February 25, 1992
LD-92-030

Docket No. 52-002

Subject: Response to NRC Requests for Additional Information

RESPONSE TO NRC REQUESTS FOR ADDITIONAL INFORMATION
STRUCTURAL AND GEOSCIENCES BRANCH

Fig. 3d Spectral Acceleration for Target Spectrum and for the Vertical Synthetic Time History -- Spectral Damping = 0.07

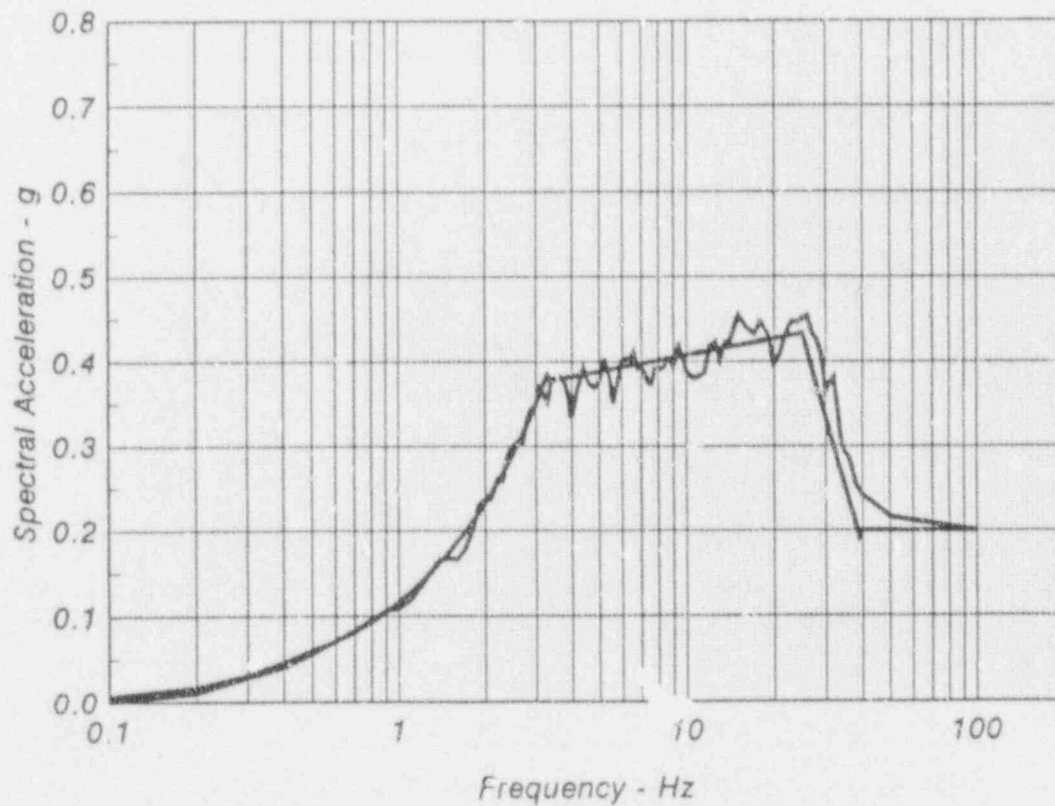
Section 3.7.1.2 - Figures 3.7-25 through 3.7-27 are for damping values of 5 percent. To show the appropriateness of these time histories, provide and discuss similar figures for other damping values that will be used in the design of all Category I structures, systems, and components.

Finally, the spectral ordinates for damping ratios of 1, 2, 5 and 7 percent were calculated for the synthetic time histories, H1, H2 and V and these were compared with the target smooth spectrum for the appropriate damping ratio. These comparisons are provided herein in Figs. 1a through 3d.

Figure 1a shows the comparison for H1 at a damping ratio of 1 percent, Fig. 1b is a similar comparison at a damping ratio of 2 percent, Fig. 1c is for a damping ratio of 5 percent and Fig. 1d is for a damping ratio of 7 percent. Corresponding comparisons are presented in Figs. 2a, 2b, 2c and 2d for H2 and in Figs. 3a, 3b, 3c and 3d for the vertical synthetic time history, V.

The results shown in Figs. 1a through 3d indicate: (i) the spectral ordinates of the synthetic time histories provide a reasonably conservative envelope to the target smooth spectrum at damping ratios from 1 to 7 percent for the frequencies of interest; and (ii) the amount of conservatism increases with decreasing damping.

CONTAINMENT PRESSURE VS. TIME

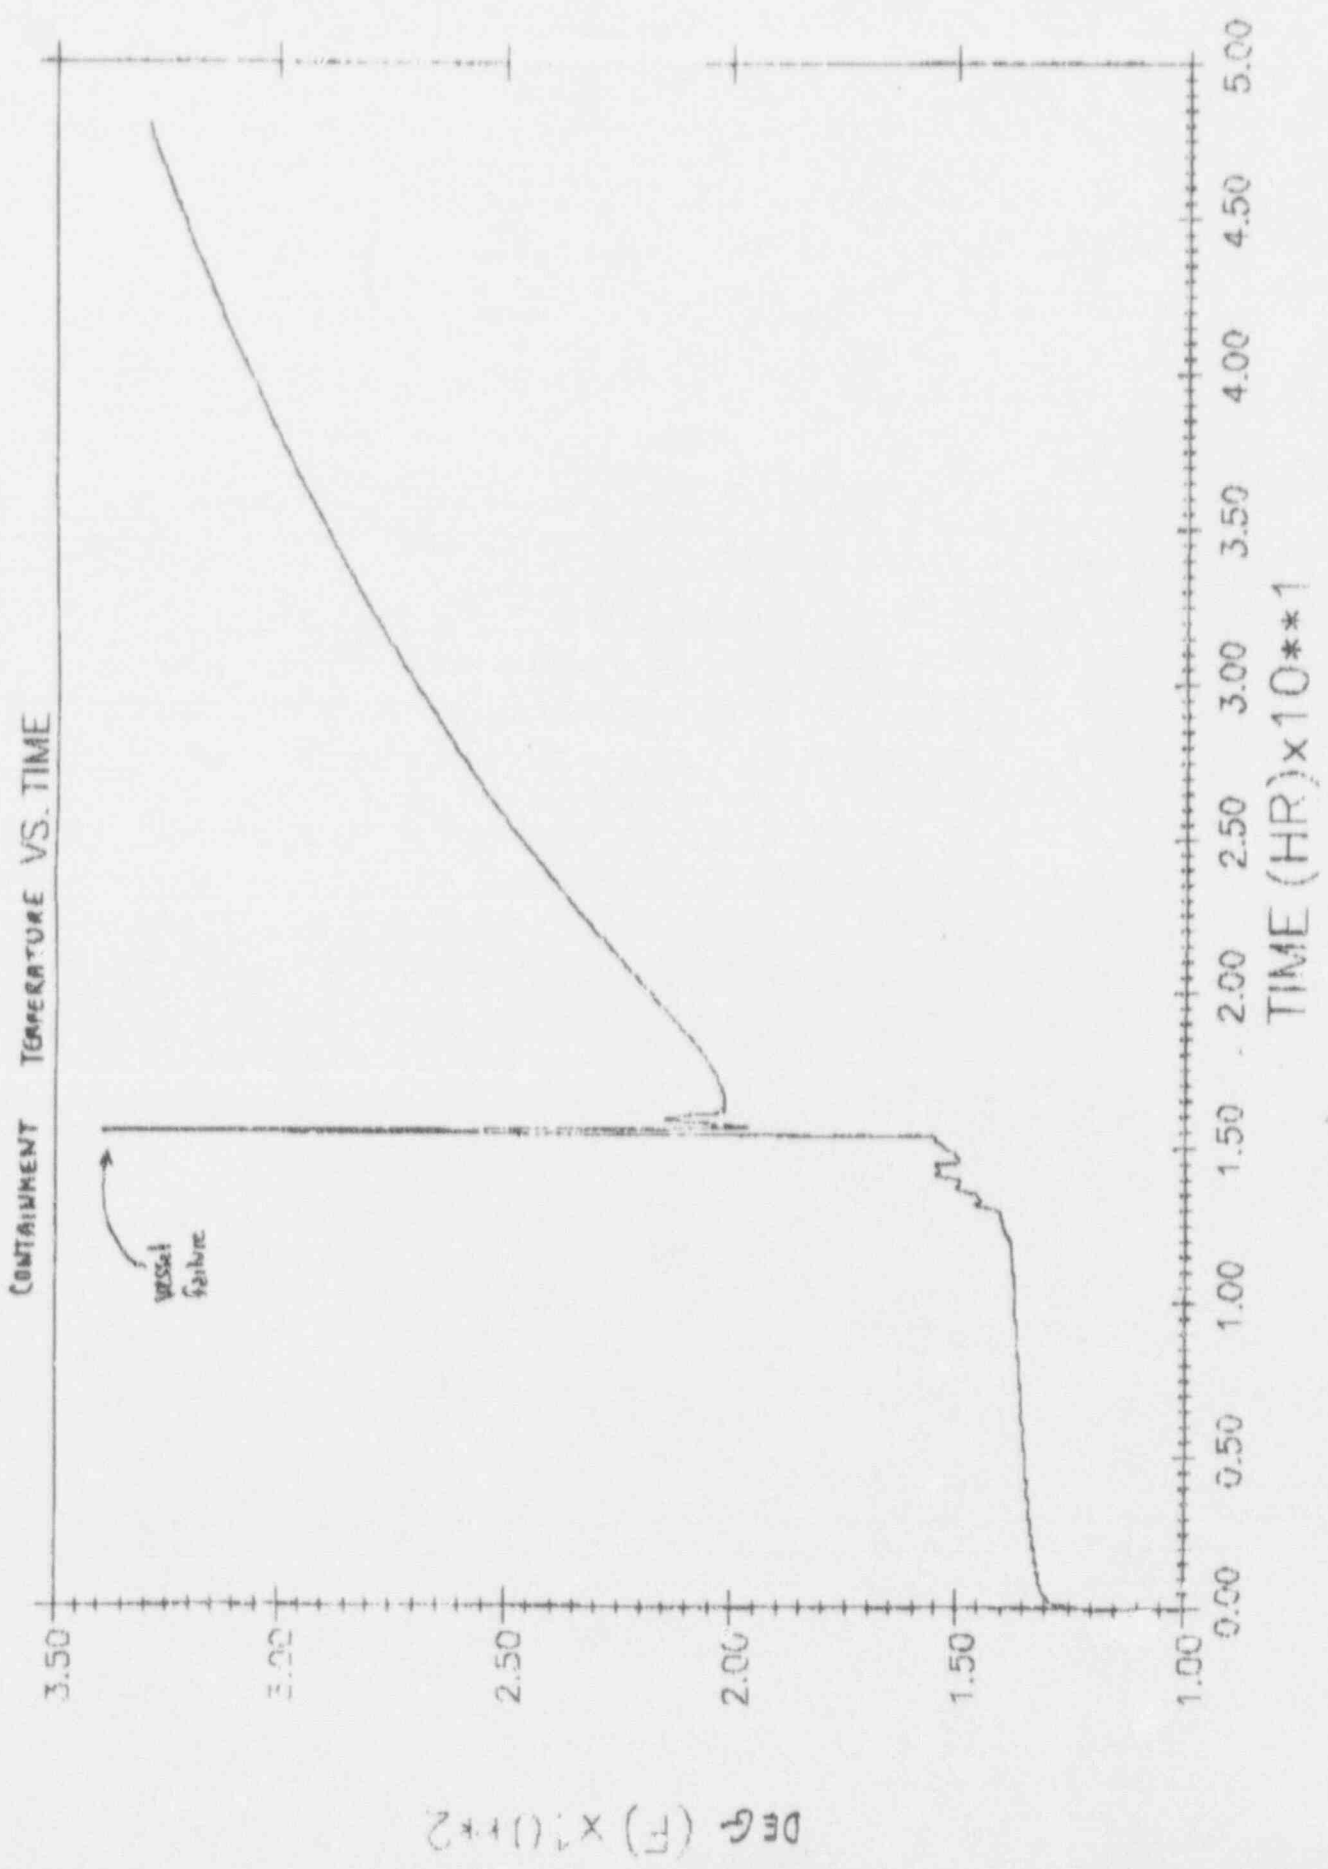
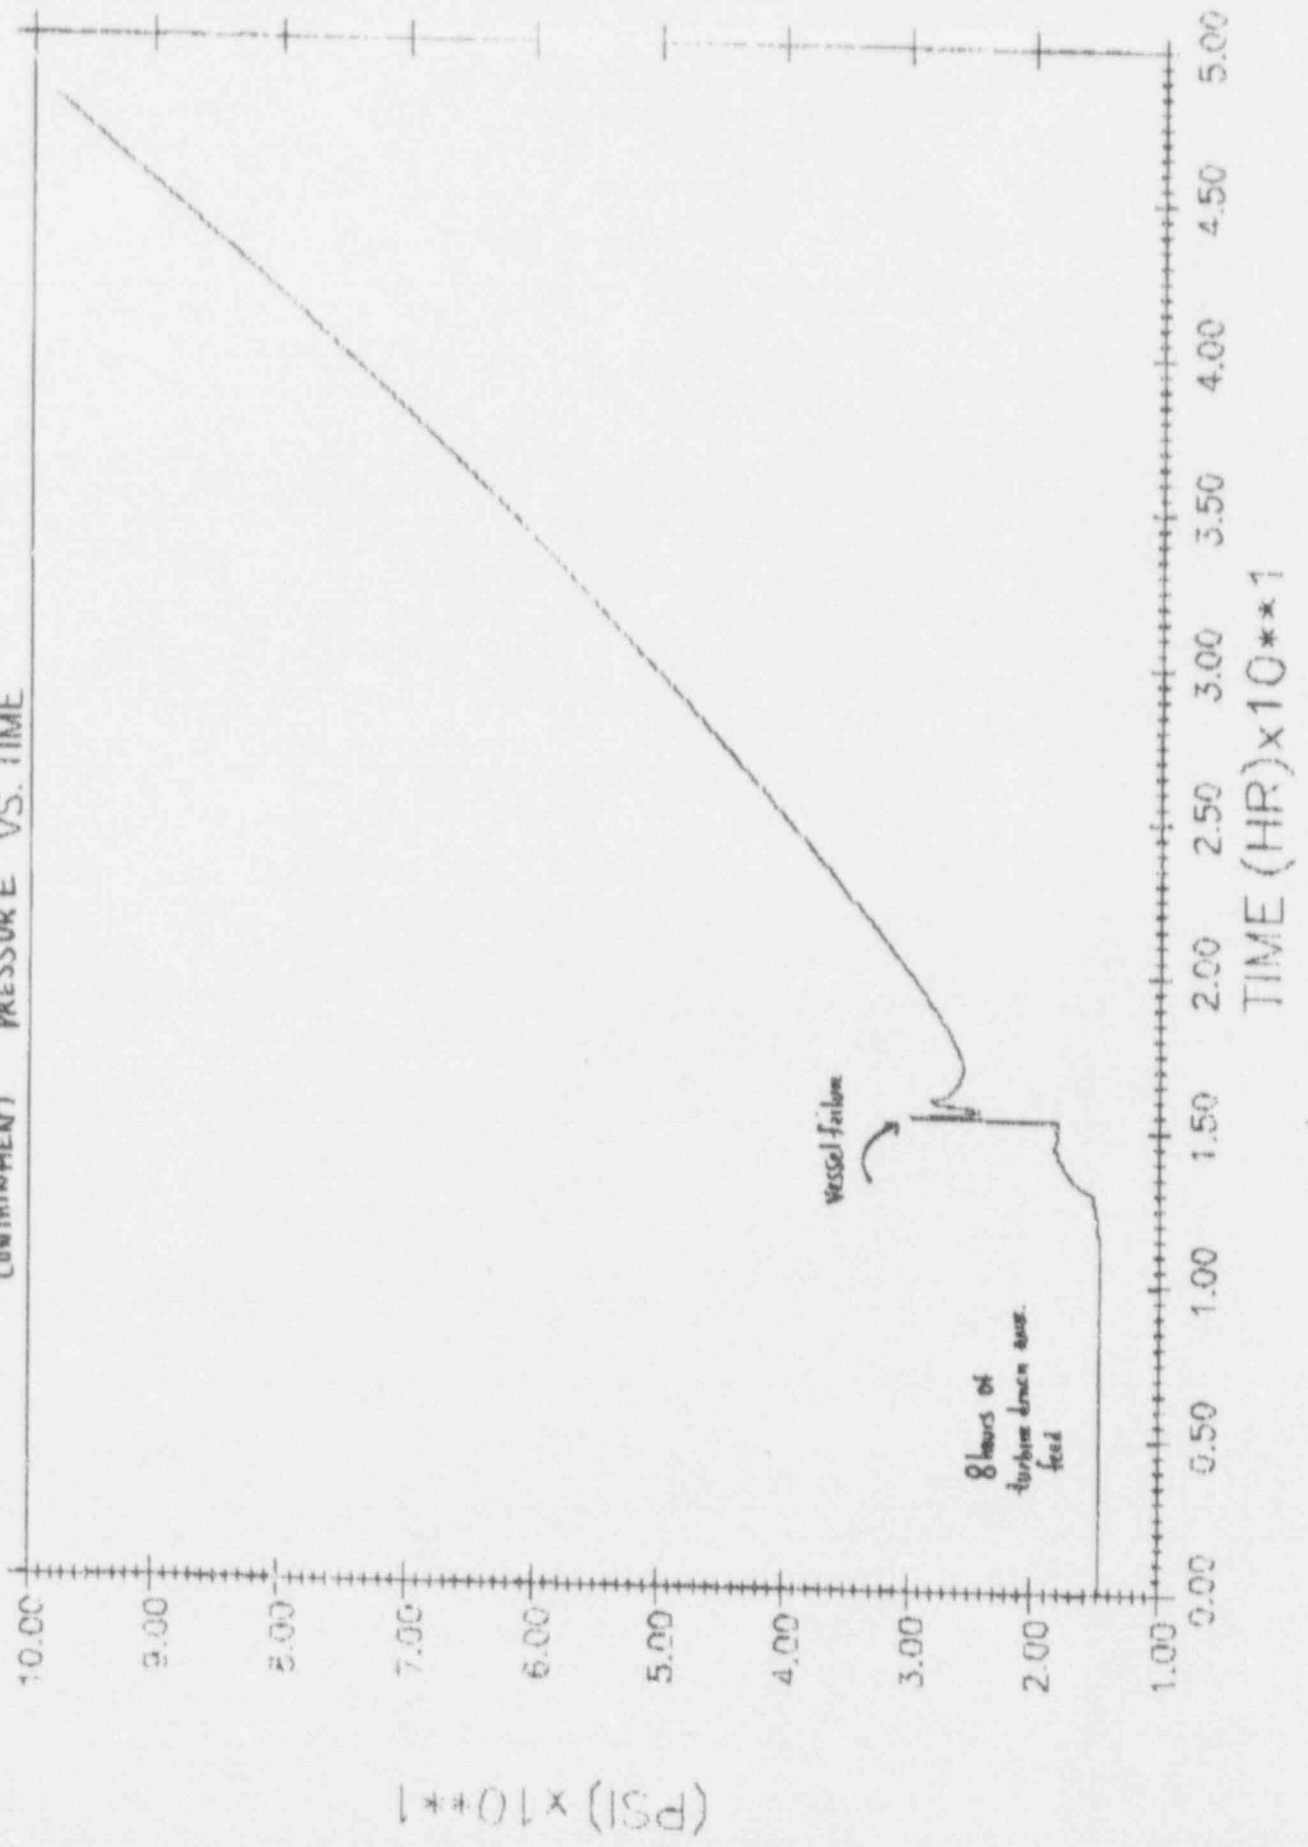
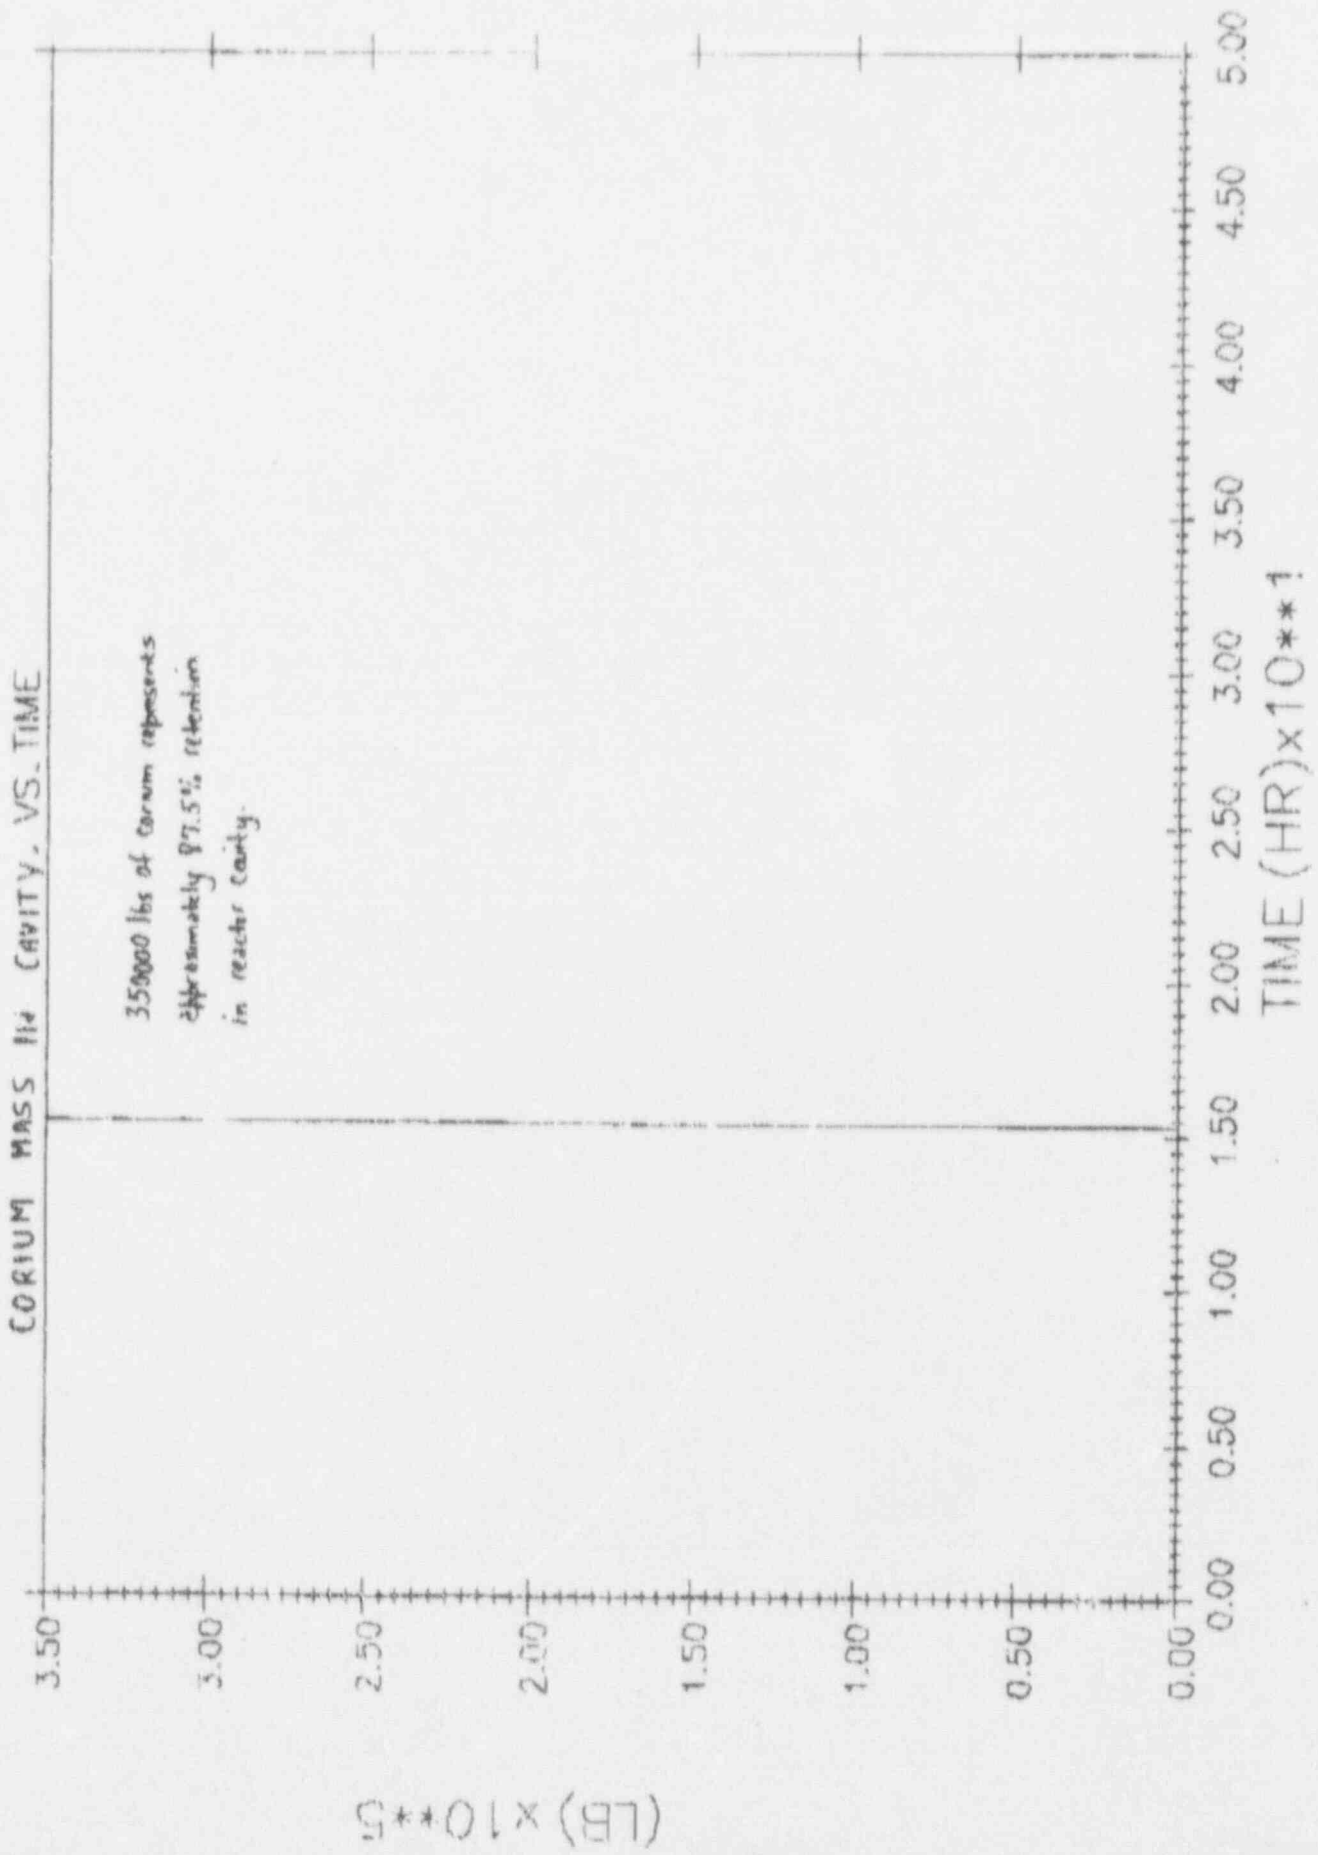
Section 5.4 Appendix B addresses the staff guidance of Containment Conditional Failure Probability (CCFP) of 0.1. The SRM related to SECY-90-016 also recommends the use of deterministic objectives. As such, the staff (ESGB) would prefer a deterministically established containment performance objective, such as establishing containment structural failure criteria based on the maximum strains (in general shell and in localized areas) as limited by global restraints and functionality of various features related to the mitigation of the consequences of accidents. Provide information regarding the ultimate capacity of the containment considering the above attributes. (see also RAI 720.24 in Section 7 of Appendix B).

For this investigation, the choice of the severe accident sequences and the assumptions on degraded core behavior will be based on best-estimate judgments which will be consistent with the MAAP analysis reported in the PRA documented in Appendix B of CESSAR-DC. The purpose of this analysis is to determine the time response of the containment pressure and temperature for a representative severe accident scenario. Using this information, the length of time the containment pressure remains below the ASME Service Level C criterion is determined. For the System 80+ containment, the ASME service Level C criterion is about 156 psia at a containment temperature of 350 degrees F.

Using the above guidelines, a station blackout scenario was simulated using the MAAP computer code. With battery power available, auxiliary feedwater flow is assumed to be provided by the turbine driven auxiliary feedwater pump for a period of eight hours. Following the unavailability of auxiliary feedwater at eight hours, the vessel fails at 15.5 hours due to the loss of core cooling. Cavity flooding is assumed to occur prior to vessel failure. Combined with the deentraining characteristic of the System 80+ cavity, this will result in the retention of approximately 87.5% of the corium within the cavity. For this scenario, the containment pressure remains below 100 psia for up to 50 hours after the initiation of the station blackout (Please see attached Figure 1). The containment temperature does not exceed 350 degrees F during this time frame (Please see Figure 2). These results demonstrate that, for this best estimate severe accident scenario, the containment pressure remains well below ASME Service Level C criterion of 156 psia for more than 50 hours.

The ultimate pressure capacity for the System 80+ containment is approximately 185 psia at a temperature of 290 degrees F. This value is not considered specifically in the above evaluation, but is included here to demonstrate the additional margin to System 80+ containment integrity during a severe accident.
